**SECTION 00 90 02
BIDDING AND CONTRACT REQUIREMENTS
ADDENDUM NUMBER 2**

Issued: March 7, 2025

Re: ADDENDUM NUMBER (2) TO THE BIDDING DOCUMENTS FOR

**McHenry County College
2024 Health Science Renovations**
Architect's Project Number: 24-032

SHEET NUMBER:
E3.00

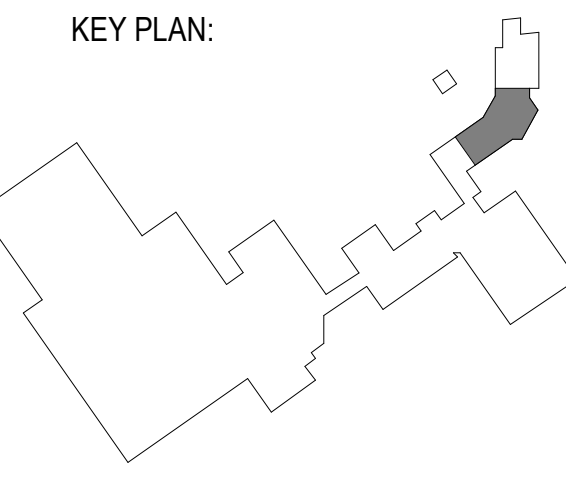
1. E1.10 - FLOOR PLANS -LIGHTING
 - a. **REVISE** lighting layout in the X-Ray Room E116C as shown.
2. E1.20 - FLOOR PLANS -POWER
 - a. **REVISE** raceway WD-1 length in the X-Ray Room E116C as shown.
 - b. **REVISE** keynote #9 as shown.
3. E3.00 - ELECTRICAL ONE LINE DIAGRAM
 - a. **REVISE** one line diagram as shown.
 - b. **REVISE** panel schedule X as shown.
